**Addendum No. (2)**  
**Central Tender No. (41/2024)**  
**Construction of Princess Muna Al-Hussein Maternity Hospital at**  
**King Hussein Medical Center/Royal Medical Services.**  
**Financed by the United States Agency for International Development (USAID)**

## Addendum No. 2

Construction of Princess Muna Al-Hussein Maternity Hospital at King Hussein  
Medical Center/Royal Medical Services.  
Financed by the United States Agency for International Development (USAID)

**First Basement Floor Drainage System**

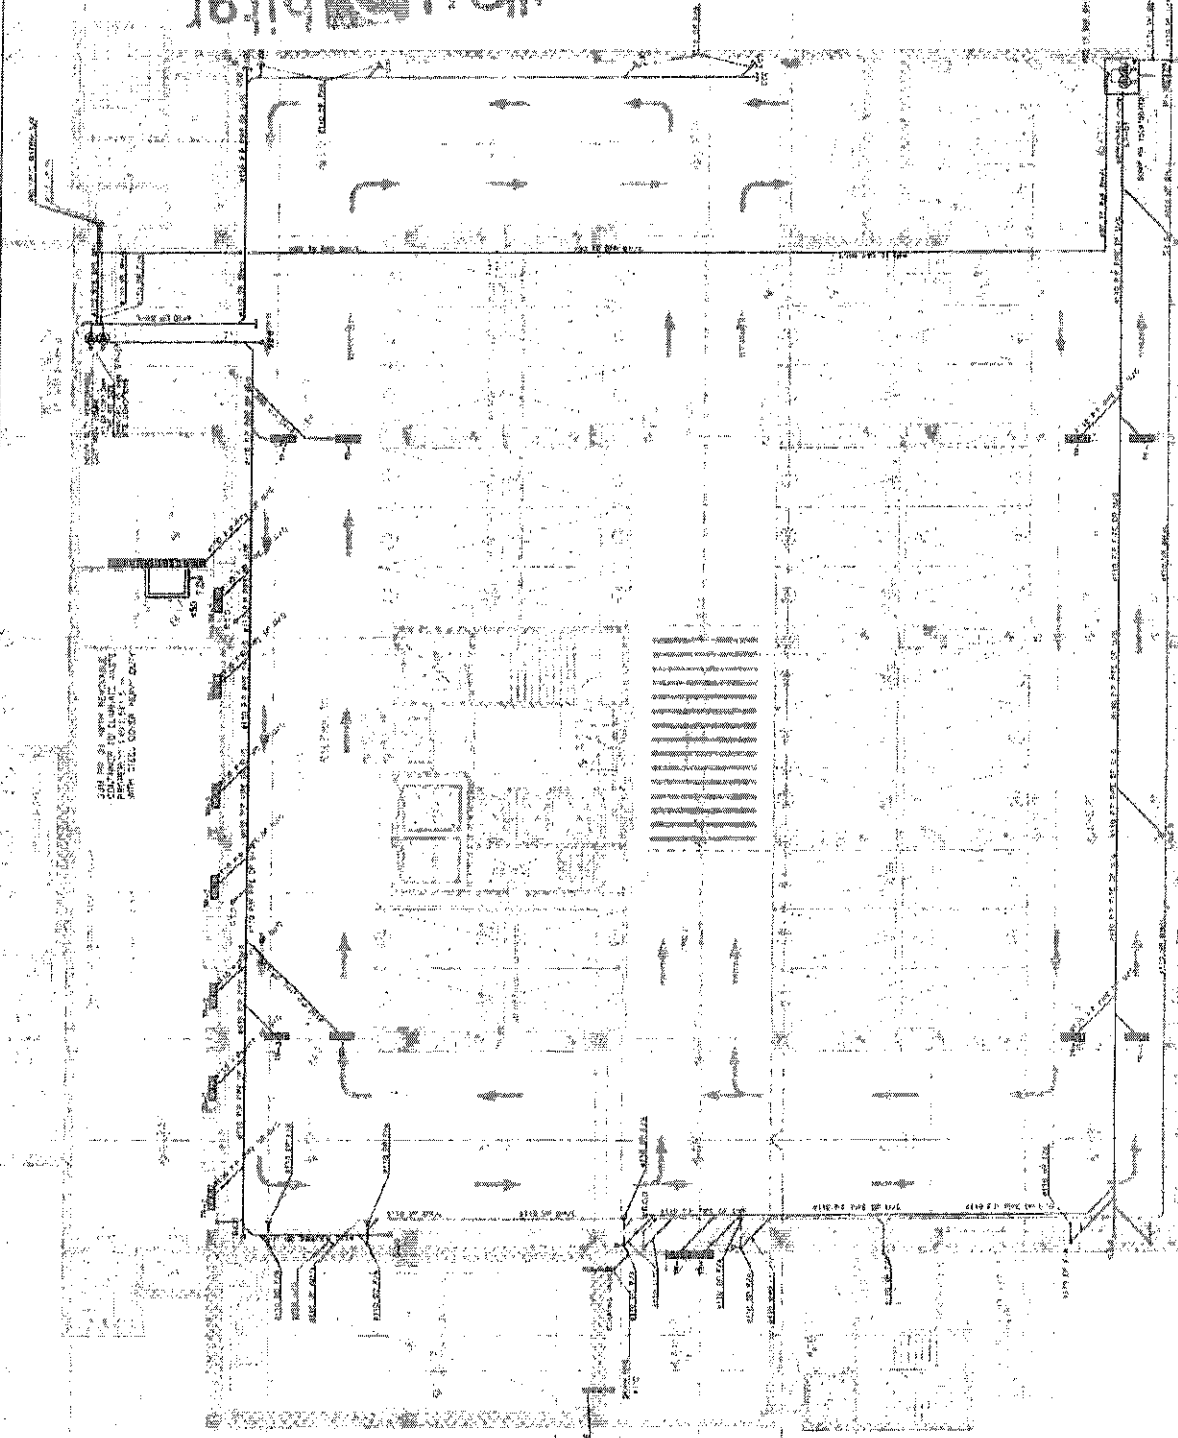
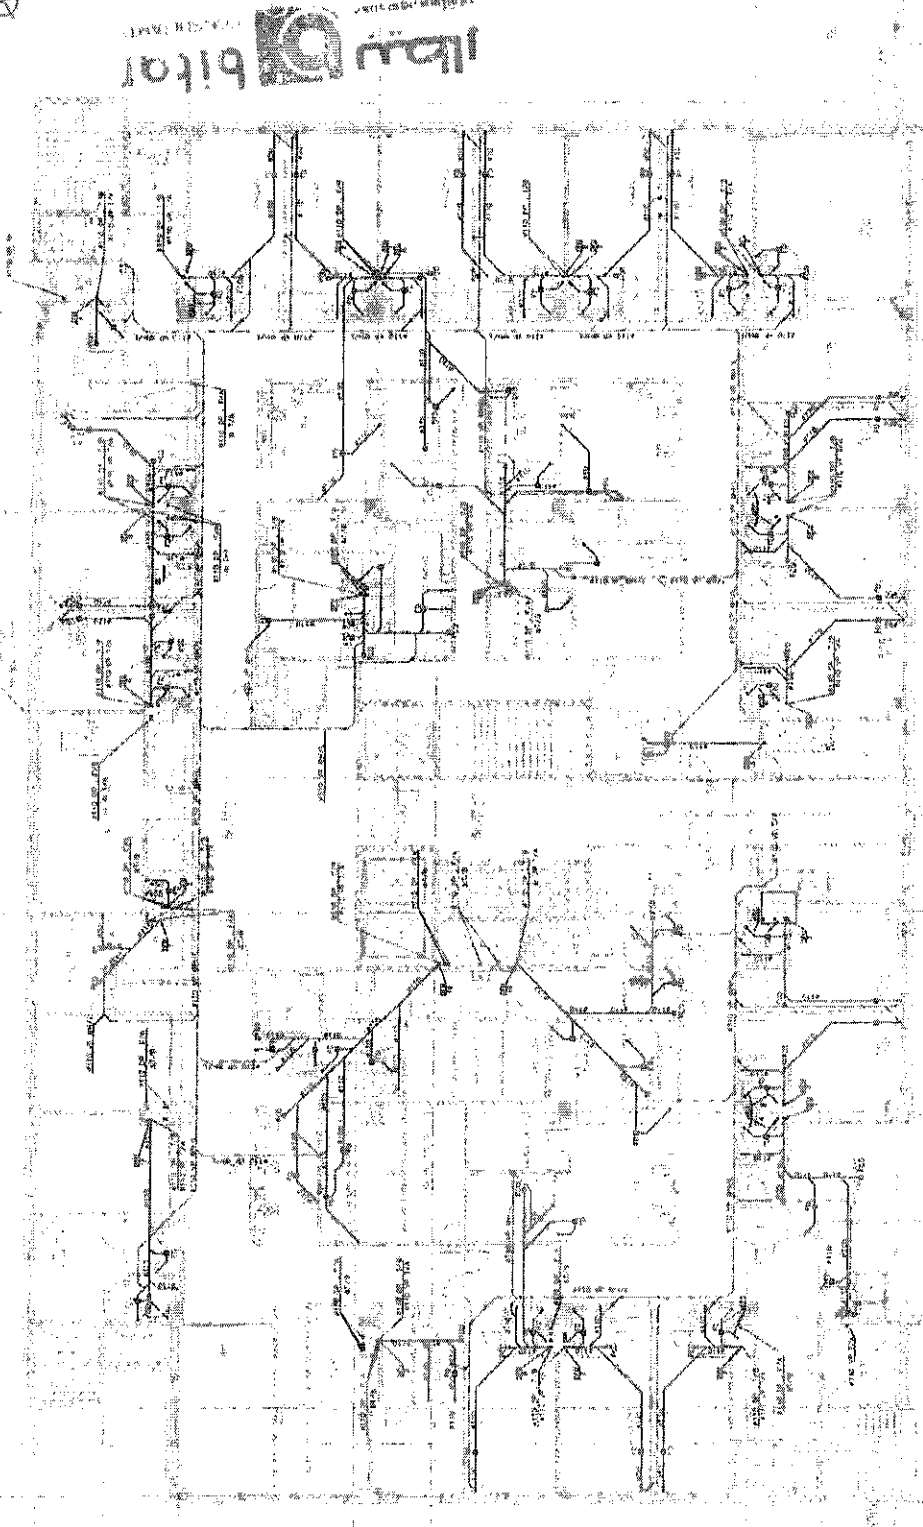
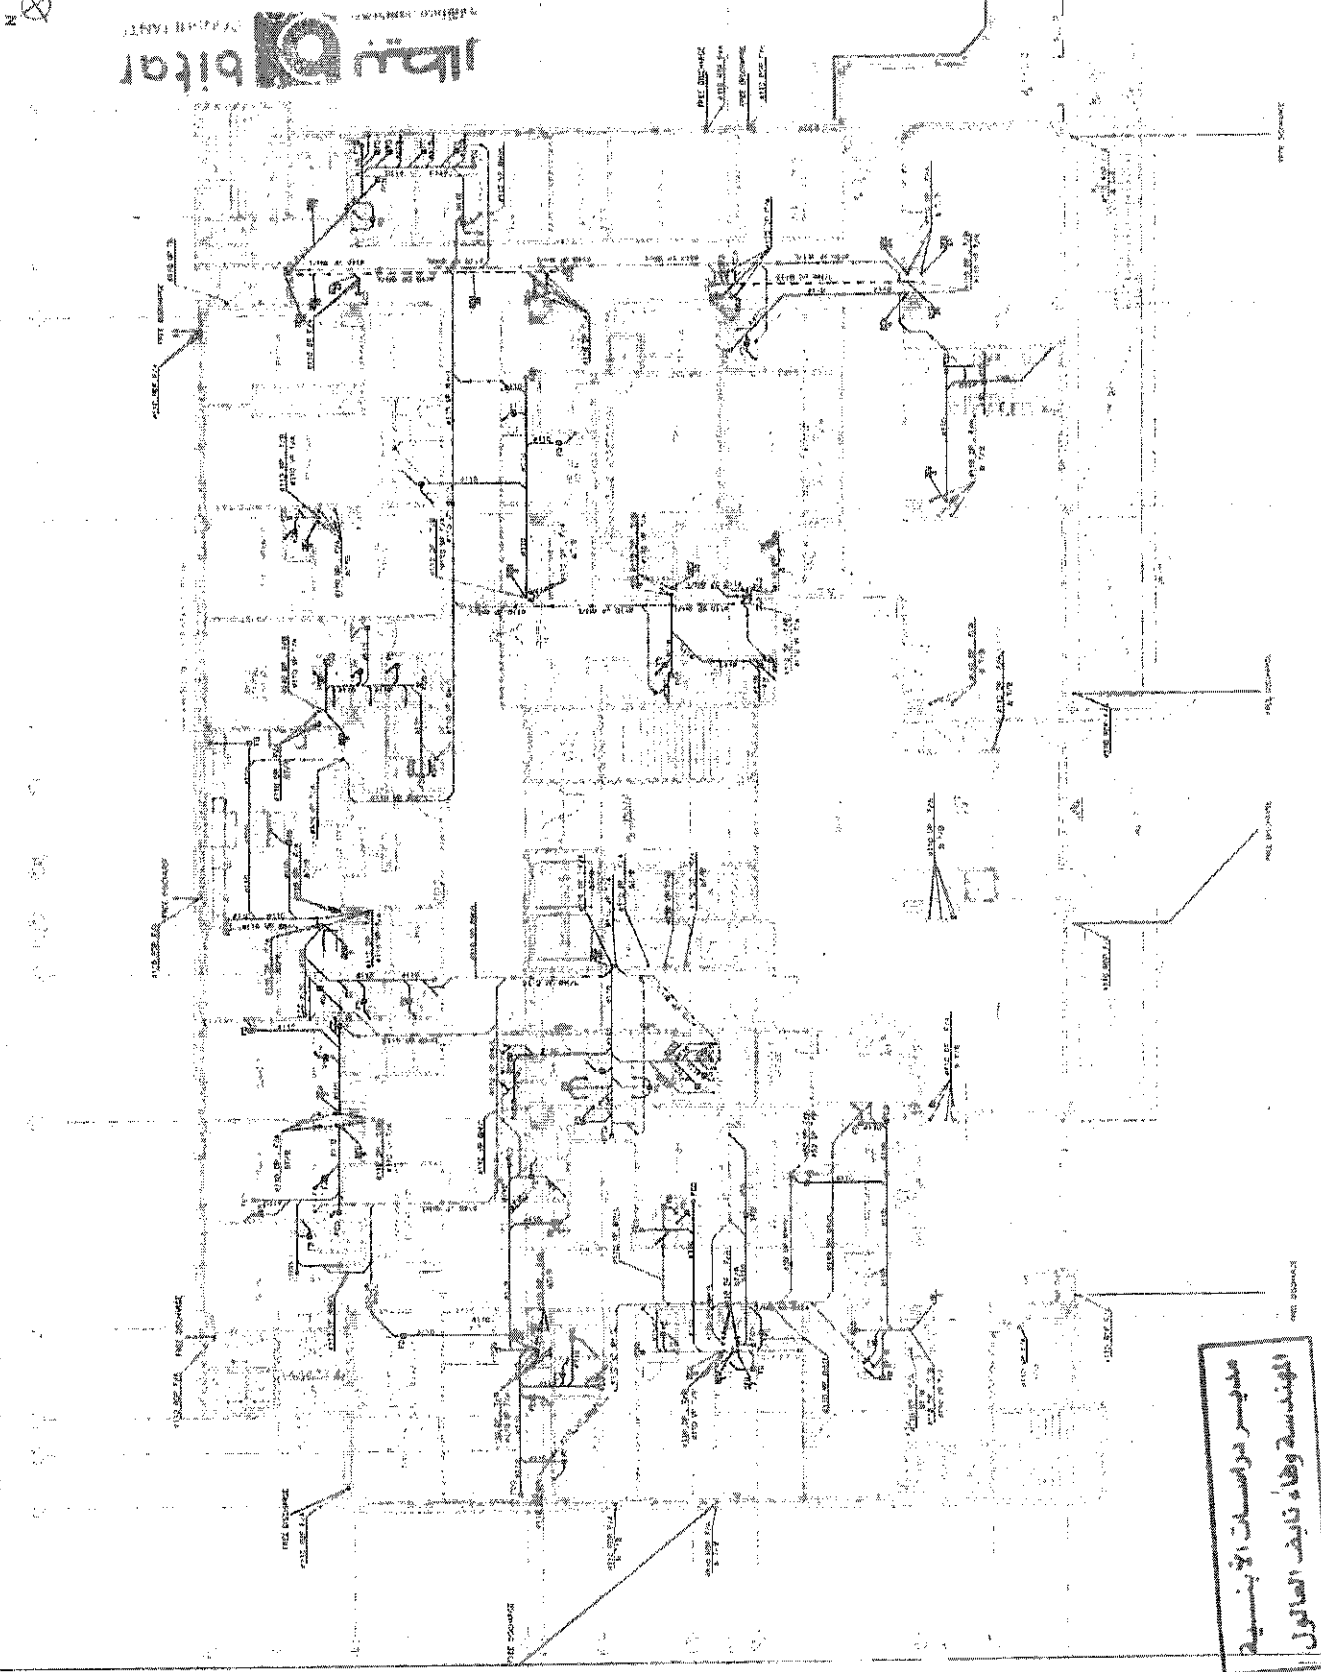
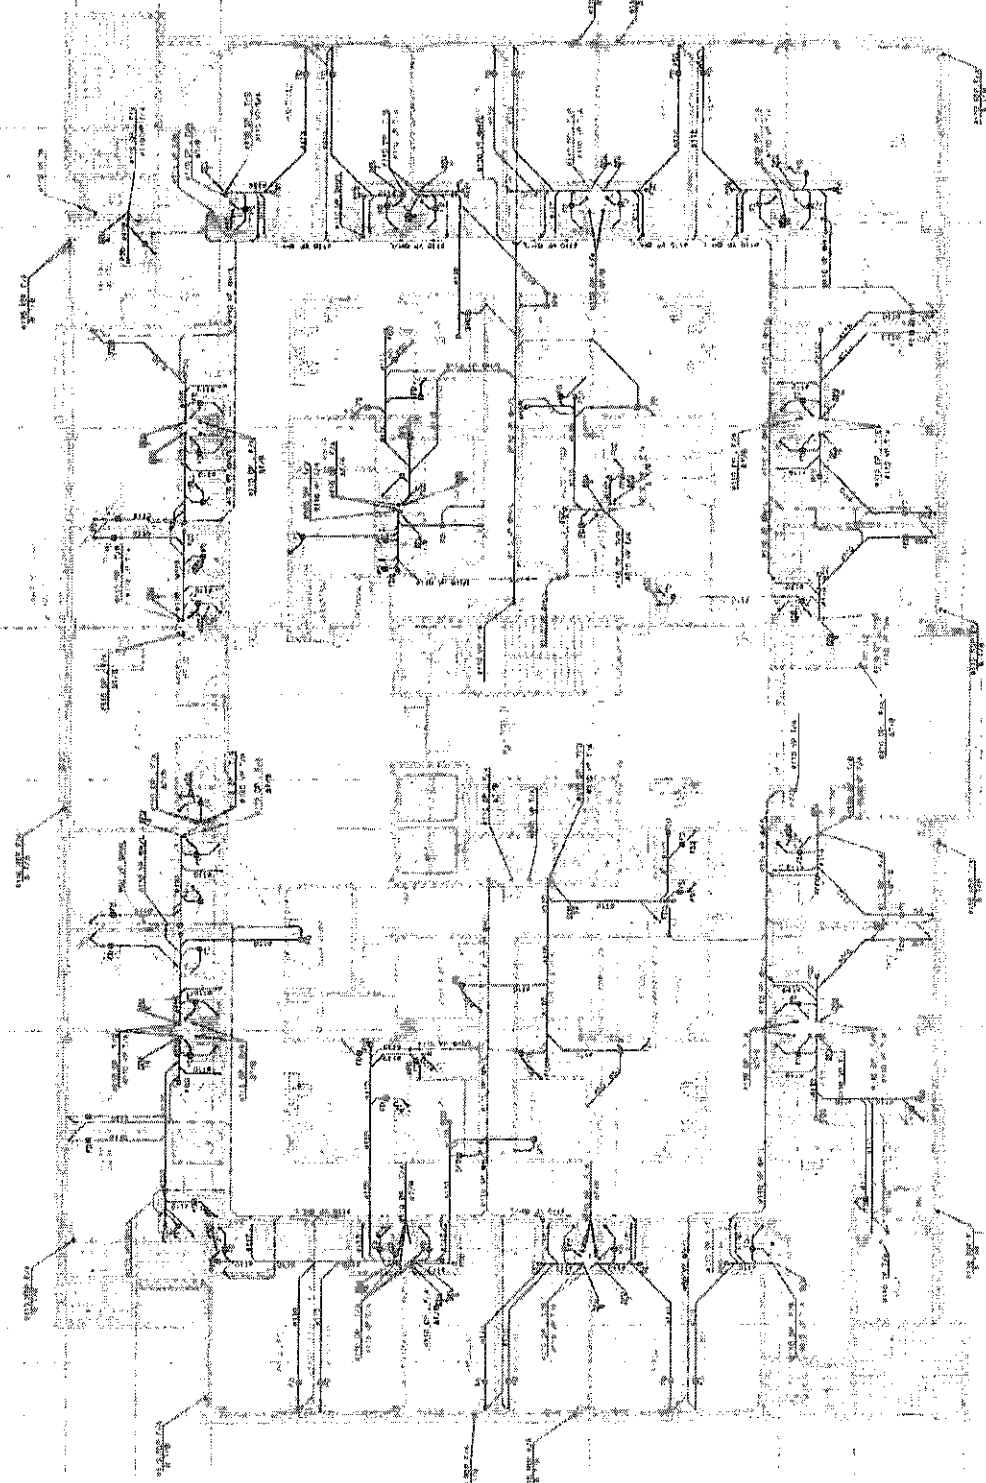
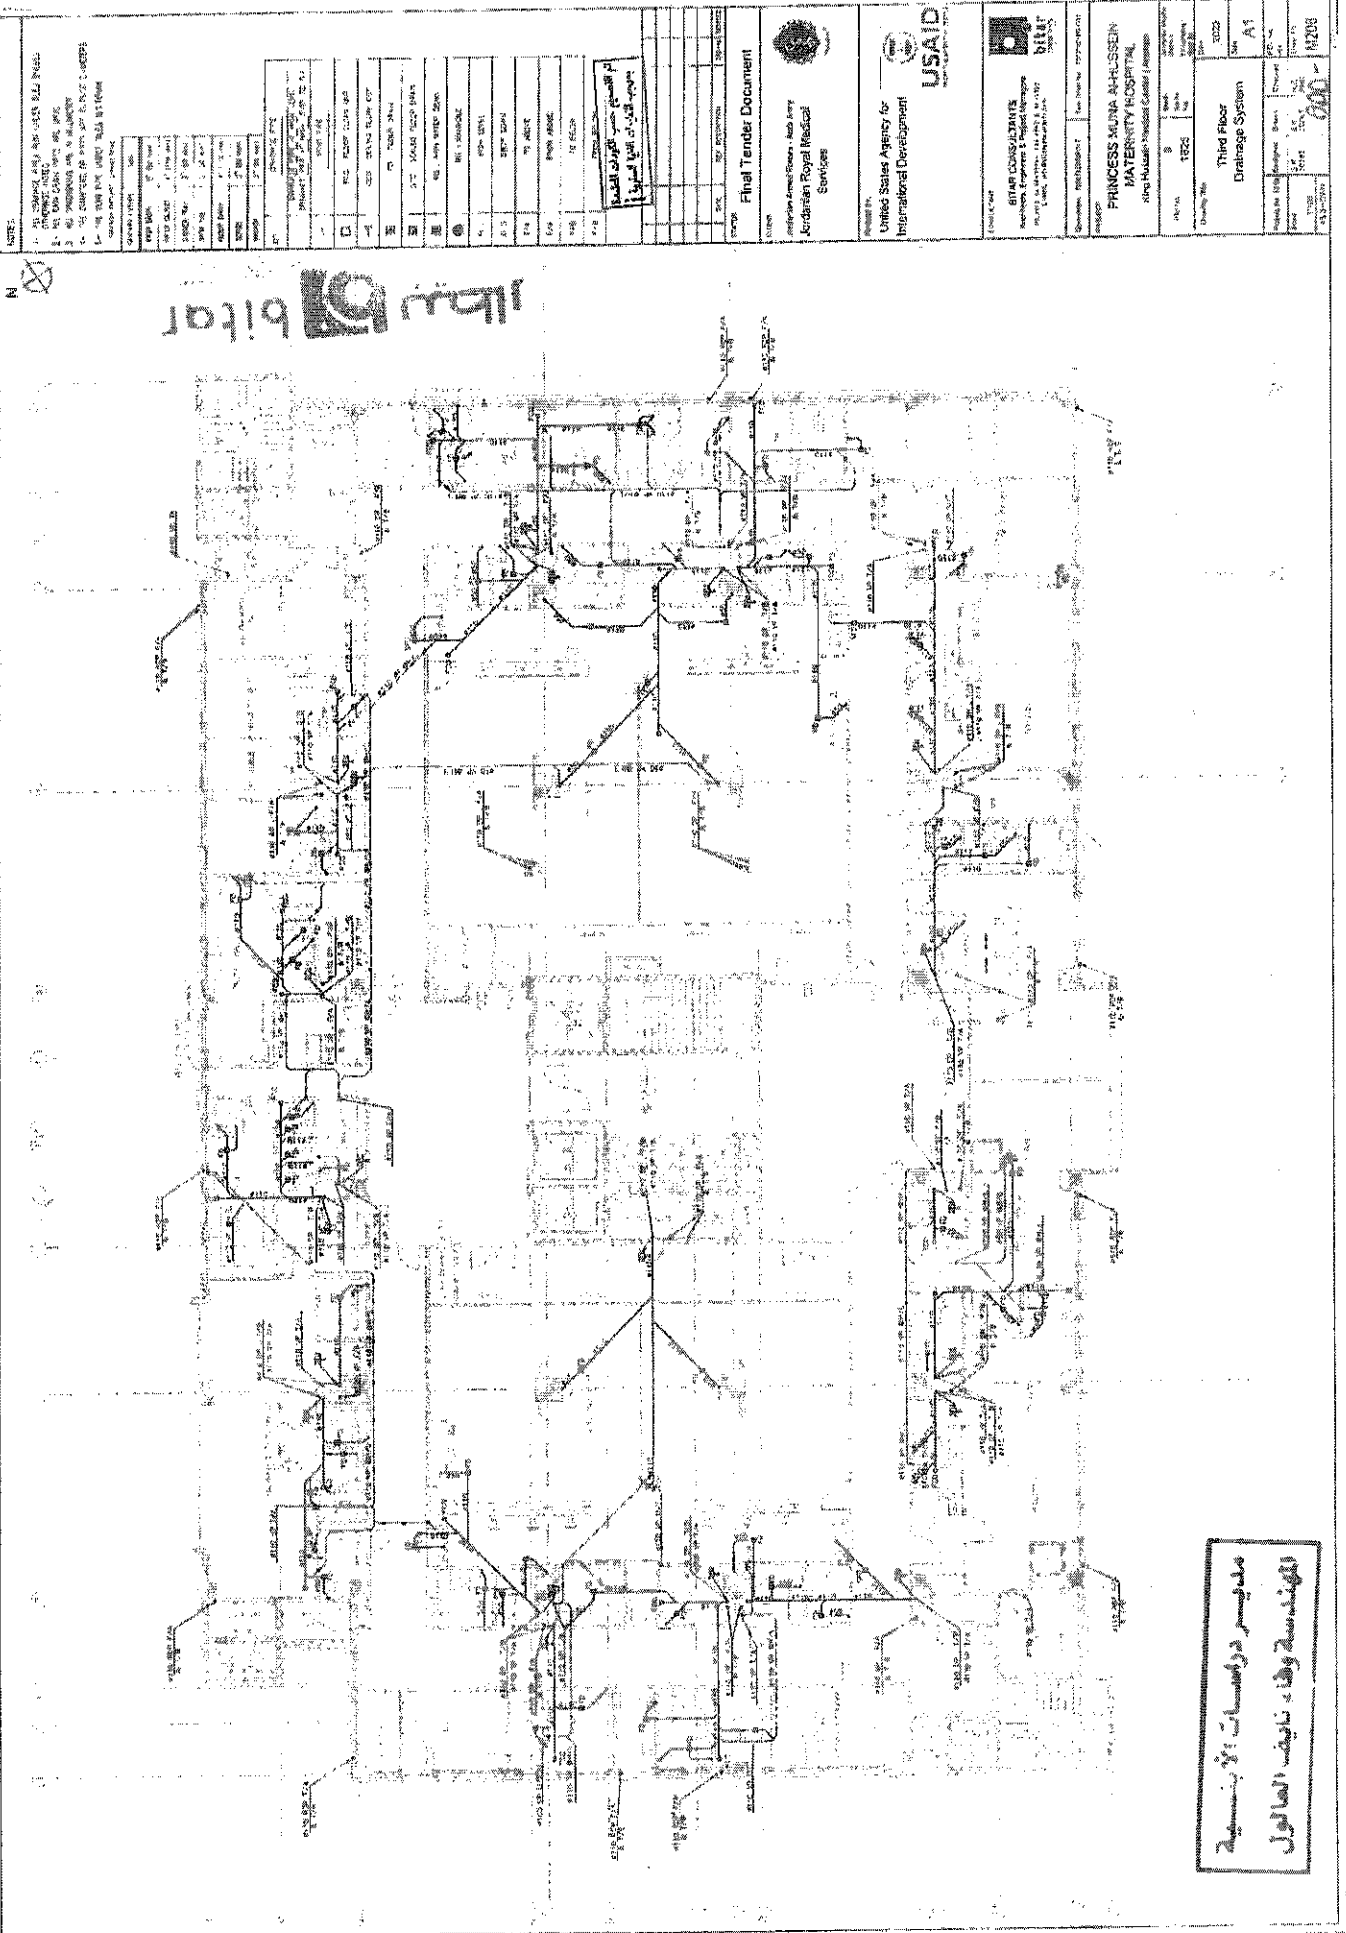
85.	About the Mechanical Drawing for the Drainage System as shown in the general note the vent pipe under the tile is 80 mm, while there is no item for Pipe 80 mm in the BOQ.	The sentence should read as follows "The vent pipe under tiles is 110 mm"  Attached is the amended drawing

1. Replace Mech Drawing No,M 201 with amended attached page ADD.M 201.
2. Replace Mech Drawings No. (M 202- M 209) with amended attached pages (ADD.M 202-Add.M 209).
